UNIMOKE MINITRAILER

VERSION 1: SIMPLE-TRAILER

VERSION 2: FOLDABLE-TRAILER

3.2 REINFORCING STRUTS

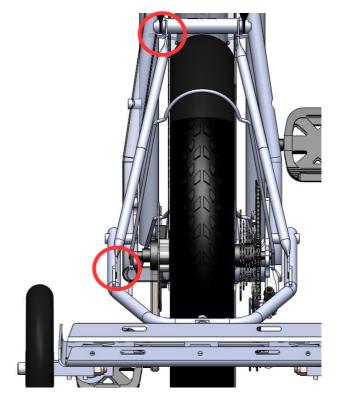
- Holes too small
- Upper hole will not fit even if it is 8mm
- Pieces don't lay flat on the brackets (angle of bend too big)

- Change hole to 10mm diameter in both ends
- Re-bend to appropiate angle

3.3 UNIVERSAL JOINT

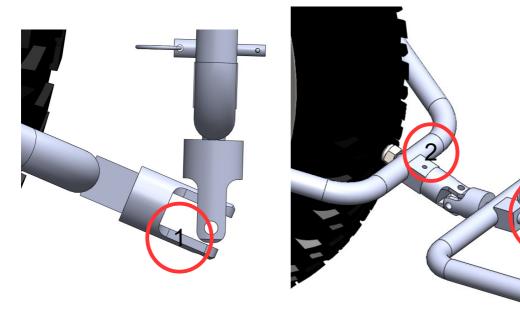
- Angle of bend not enought for folding up (they are only 90°)
- Need additional holes for fix to the structure (for security added to the nut) and to the trailer

- Make longer pieces for the joint (9mm longer each) to allow for greater bend angle (1)
- Add 4mm hole in the support side (fitting the 4mm hole in the square block of the support) (2)
- Add 5mm hole in the trailer handle side (3)
- Add a 5mm ball lock pin to fix the joint to the trailer. (4)
